10328 PLAZA RD EXT

CERTIFICATE OF COMPLETION/OPERATION PERMIT

INSTALLATION, CONSTRUCTION, ALTERATION, AND/OR REPAIR APPROVAL

NAME OF OWNER IGLESIA DE DIOS NUEVA VIDA

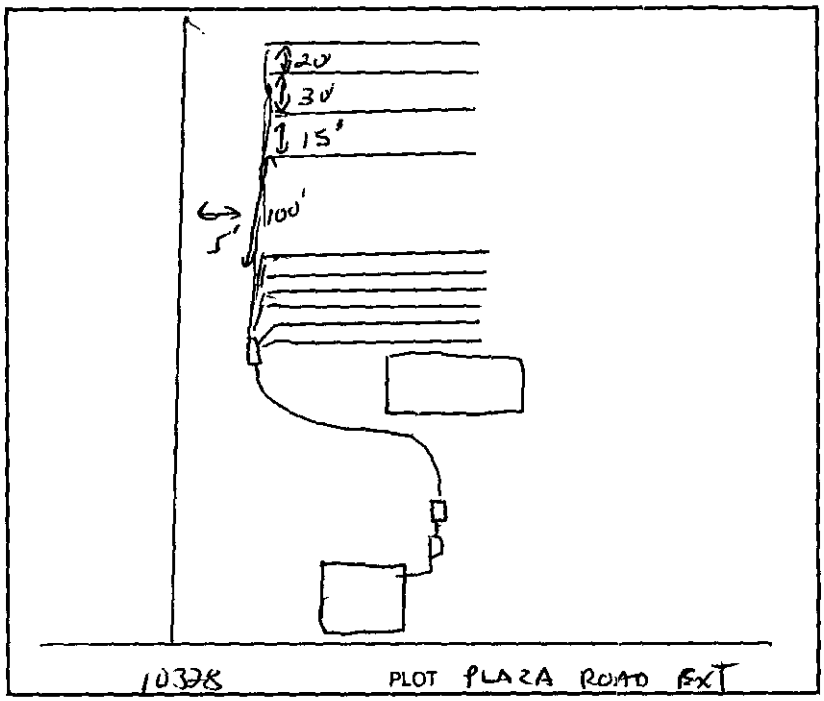
COMMENTS: TYPE III-B, G. 4 LINES added @ 101' EACH., 5 EXISTING 133' CUT OFF. NEW RISER INSTALLED. ALL ELECTRICAL COMPONETS ENCLOSED. SUPPLY LINE ENCLOSED.

PLOT OF SYSTEM

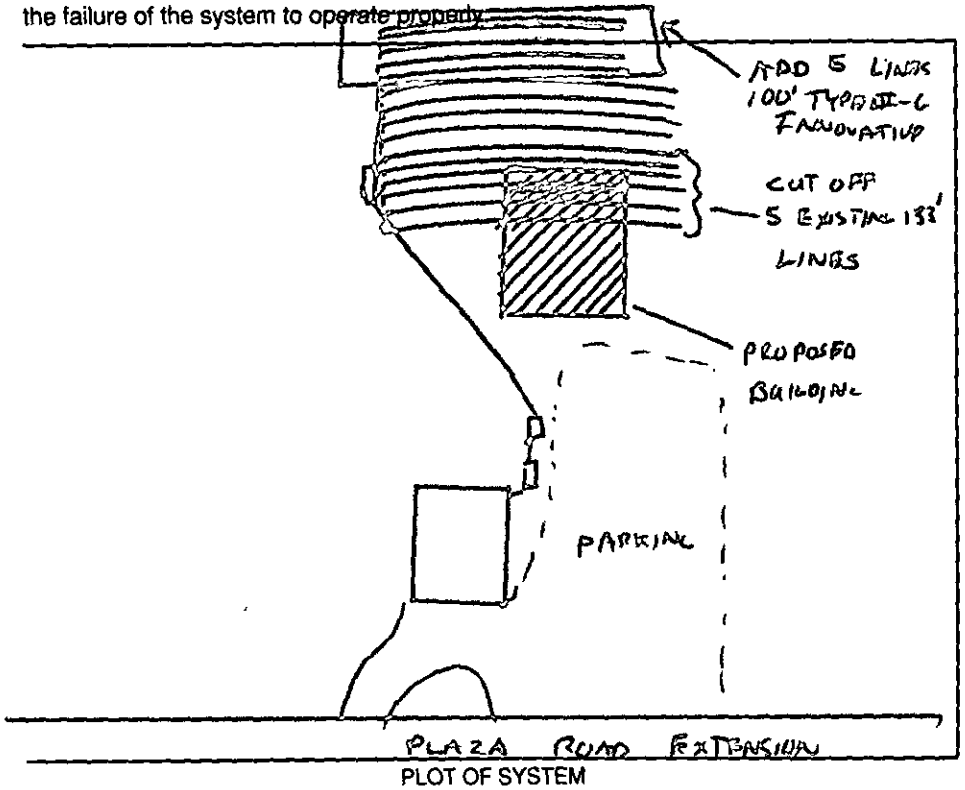
Comments: (1) RE-ROUTE 2" SUPPLY LINE IF IT IS UNDER PROPOSED BUILDING (2) CUT-OFF 5 EXISTING 133' LINES AND REPLACE WITH (5) 100' TYPE II-C INNOVATIVE LINES. (3) NEW PRESSURE MANIFOLD MAY BE REQUIRED (4) INSTALL NEW RISER OVER PUMP TANK

PLOT OF SYSTEM

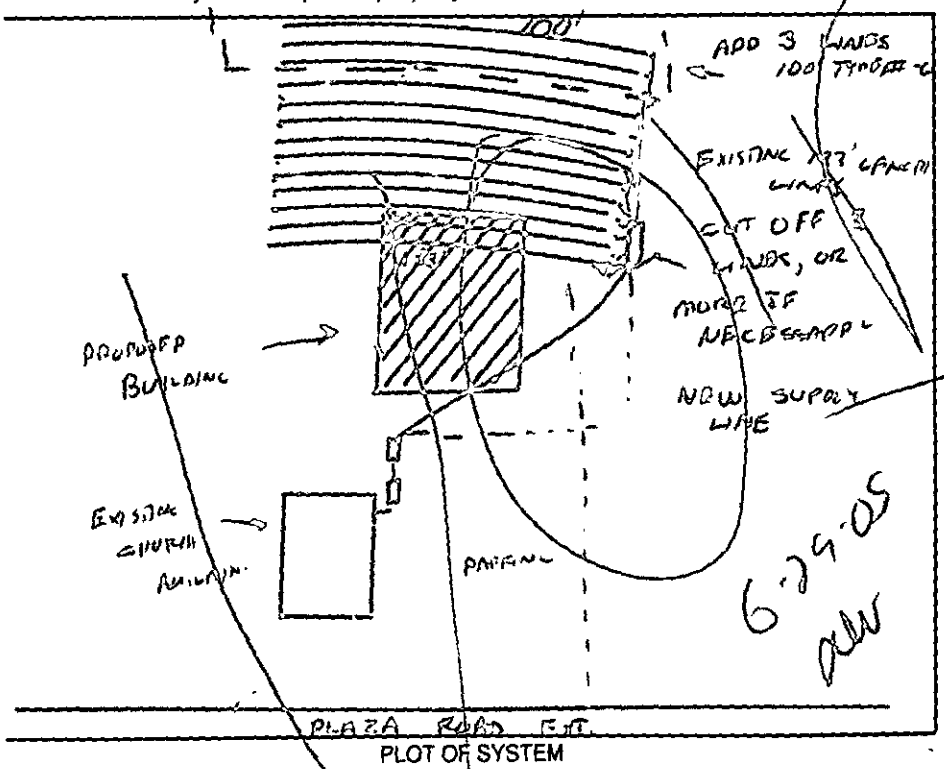
Comments: (1) REROUTE 2" SUPPLY LINE

(2) CUT OFF 3 LINES, MORE IF NECESSARY AND RE-LOCATE AS SHOWN

(3) NEW PRESSURE MANIFOLD MAY BE NECESSARY

(4) INSTALL NEW RISER OVER PUMP TANK W/ SECURE LID.

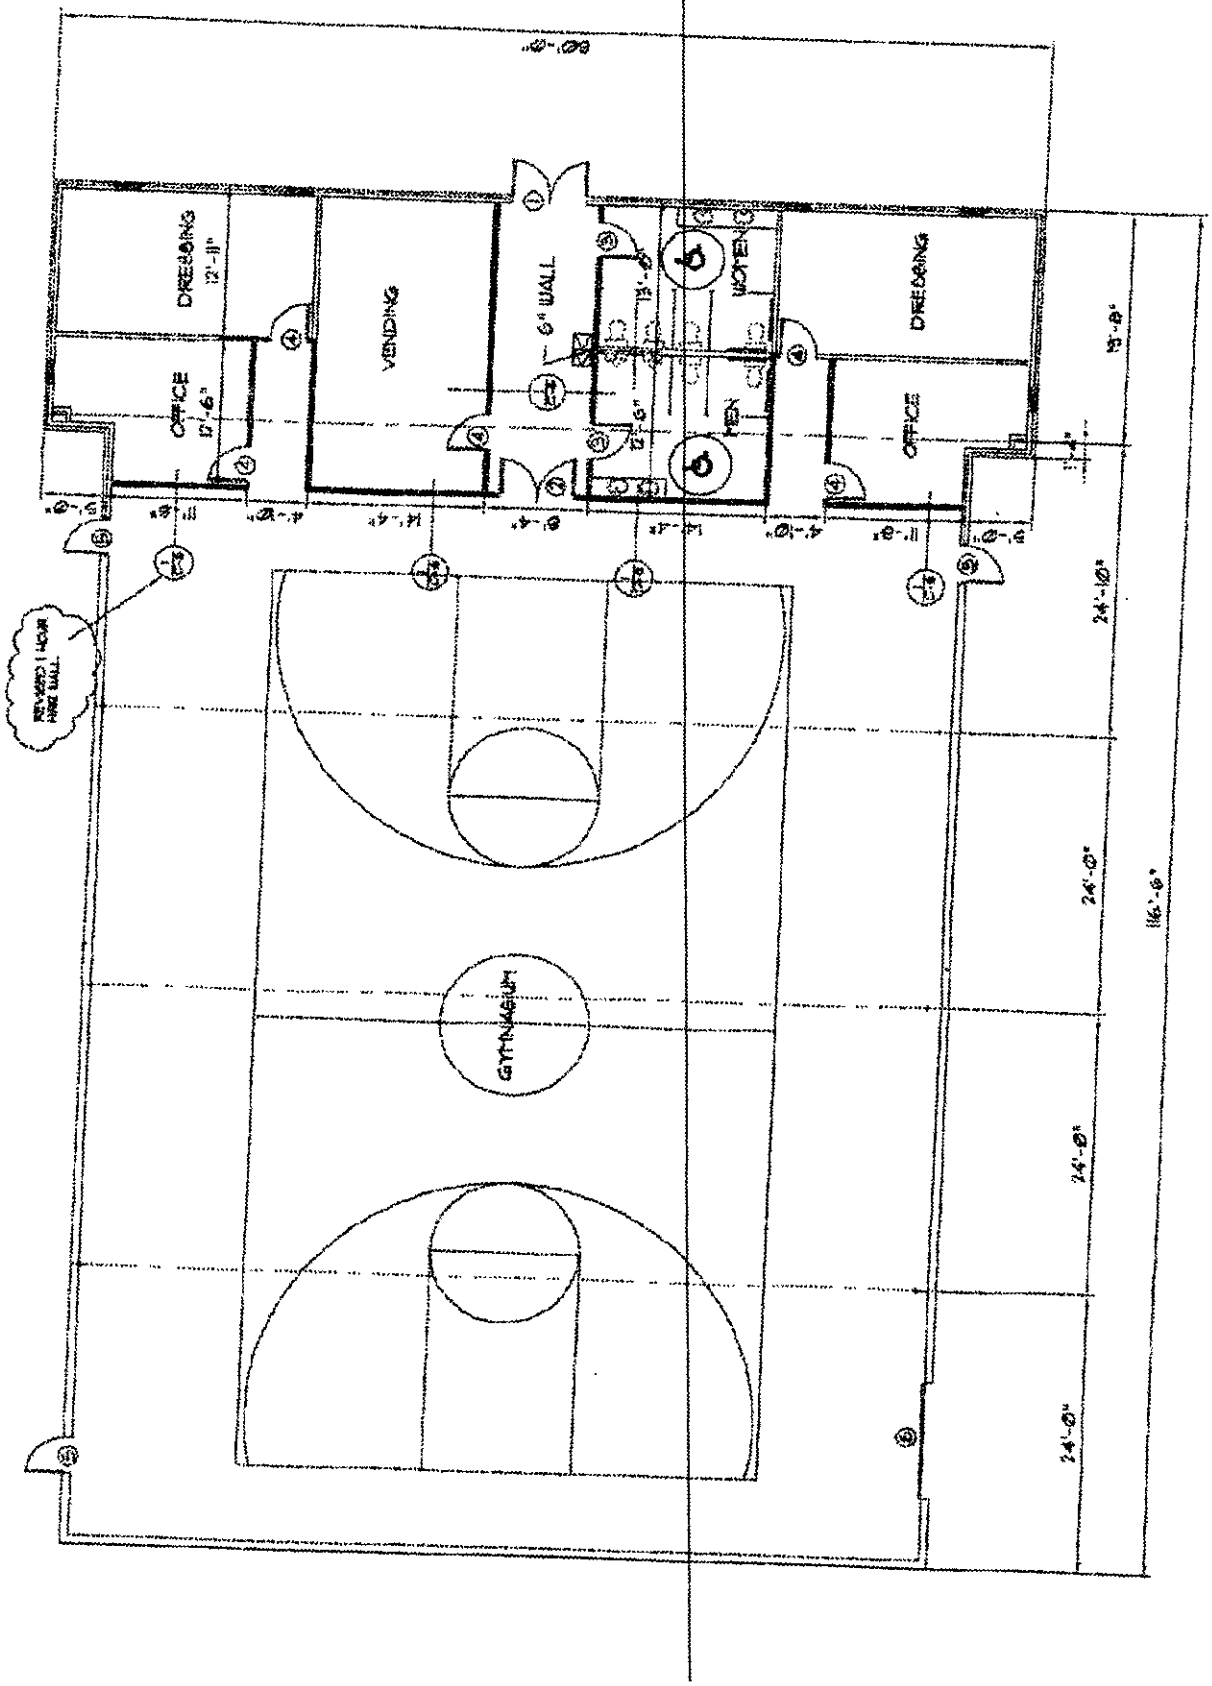
COMMENTS Septic system Designed for 240 seat church w/ Kitchen, Pressure Manifold Septic Design 1500 ST, 1500 DT, PI, Keep supply line > 30" under parking pavement / 10 lines x 133'long x 3'wd x 12"stone, 1333 TLF, TYPE III Repair Area, Municipal Water Keep septic system > 100' from any wells. Keep lines on contour of land

PLOT OF SYSTEM

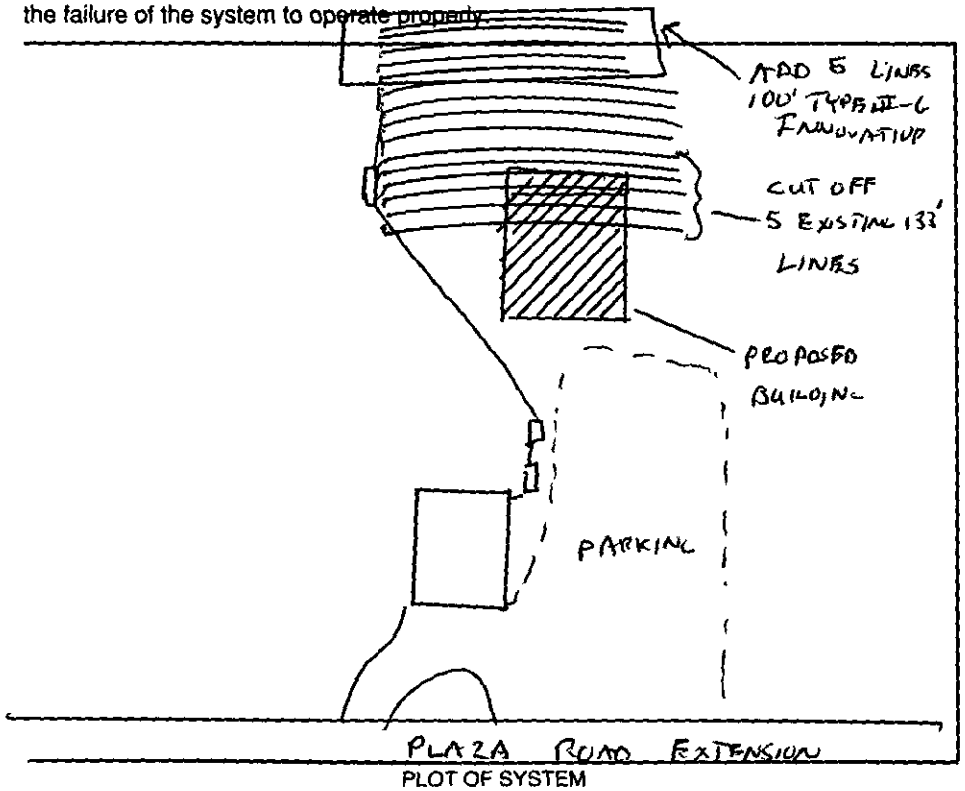
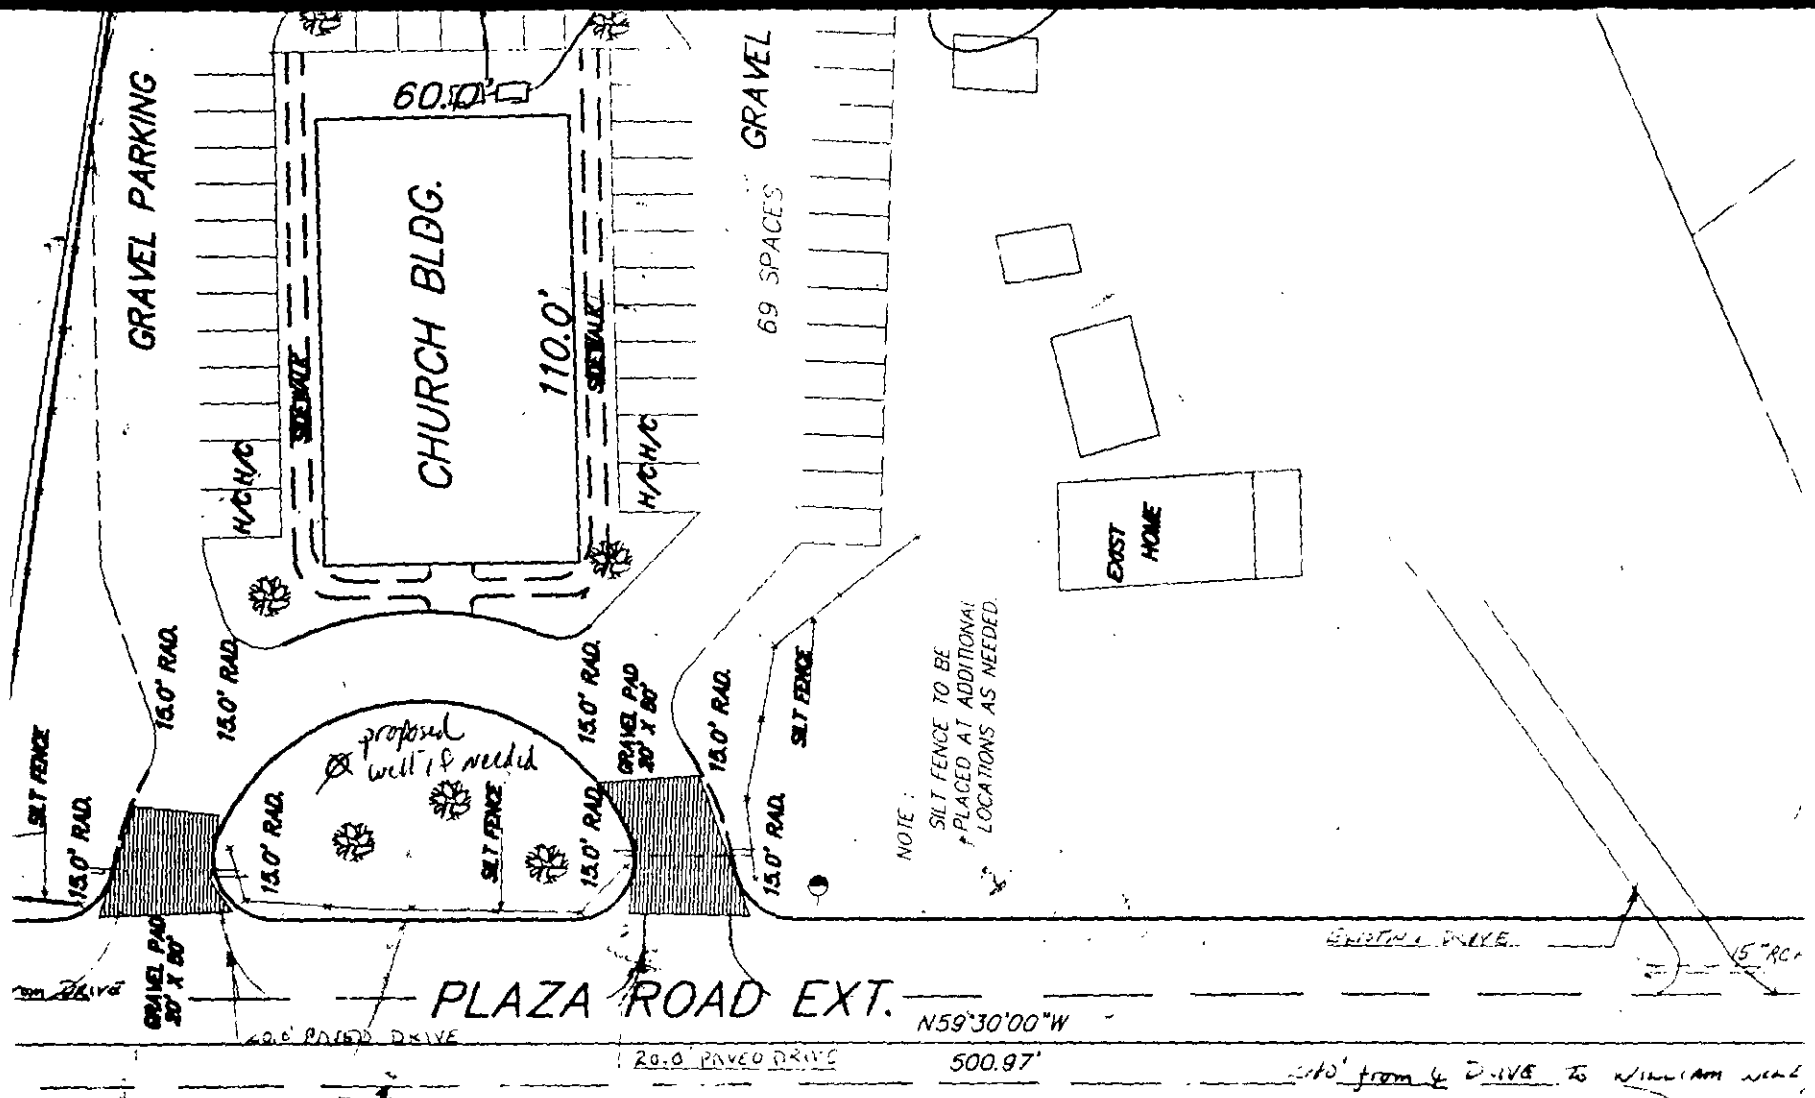
Comments: (1) RE-ROUTE 2" SUPPLY LINE IF IT IS UNDER PROPOSED BUILDING (2) CUT-OFF 5 EXISTING 133' LINES AND REPLACE WITH (5) 100' TYPE III-C INNOVATIVE LINES. (3) NEW PRESSURE MANIFOLD MAY BE REQUIRED (4) INSTALL NEW RISER OVER PUMP TANK

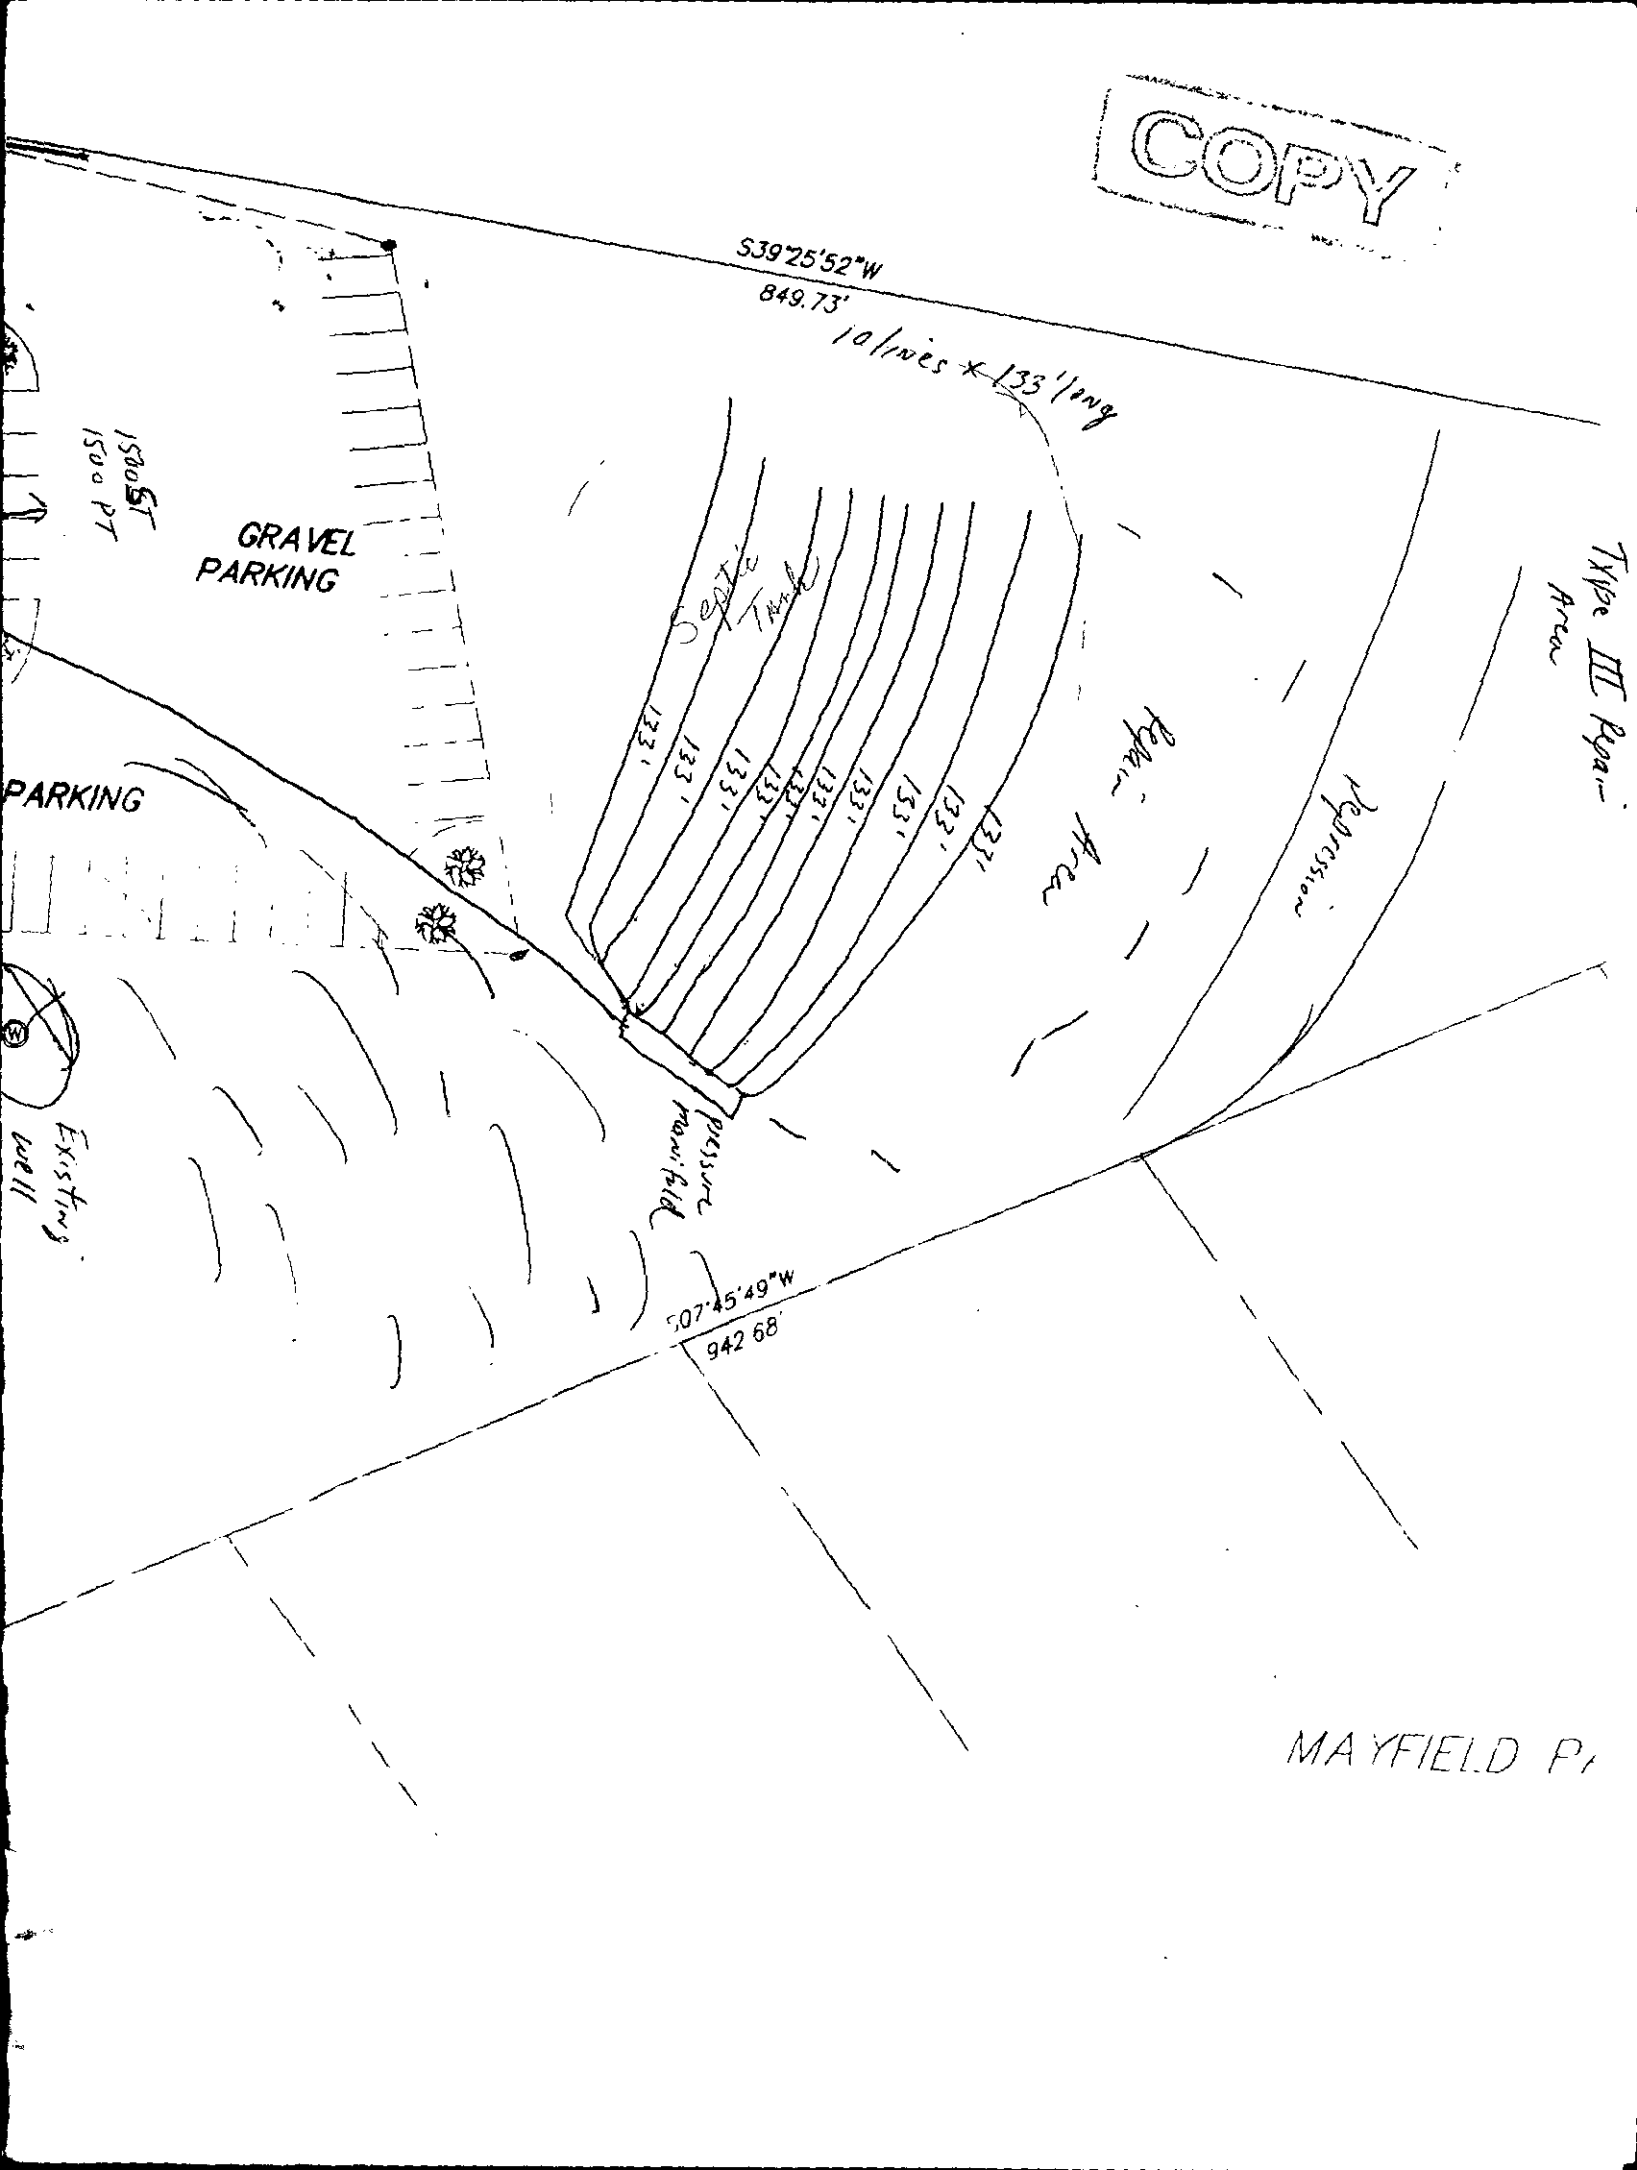
COMMENTS Septic system designed for 240 seat church w/ Kitchen, Pressure Manifold Septic Design 1500 ST, 1500 DT, PI, Keep supply line > 30" under parking pavement / 10 lines x 133'long x 3'wd x 12" stone, 1333 TLF, Type III Repair Area, Municipal Water, Keep septic system > 100' from any wells. Keep lines on contour of land
